UNITED STATES PATENT AND TRADEMARK OFFICE

| APPLICATION NO. | FILING DATE | FIRST NAMED INVENTOR | ATTORNEY DOCKET NO. | CONFIRMATION NO. |
|---|-------------|----------------------|--------------------------|------------------|
| 10/752,936 | 01/07/2004 | James Loyd | 930027-2022 | 5800 |

| Office Action Summary | Application No. 10/752,936 | Applicant(s) LOYD ET AL. | |

DETAILED ACTION

Fig. 2

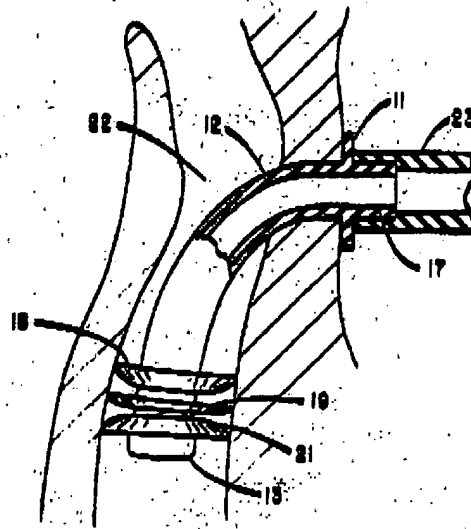
37. **As to Claims 10 and 20**, Bertoch is discussed above, yet fails to teach the first and second flanges being opposedly curved. Miller discloses a tracheal tube seal consisting of "a series of thin, solid, resilient, disc-like flanges (18, 19, and 20) preferably attached to the tubular portion (12) in spaced parallel relationships perpendicular to the axis of the tubular portion" (Please see column 2, lines 13-16). Seen below is Figure 2 of the Miller patent showing the device inserted into the patient.

38. As seen above, the flanges (18 and 21) have become opposedly curved as a result of the flexible nature of the material used to create the flanges and insertion into the patient's trachea. Regarding the middle flange (19), Miller teaches that a choice
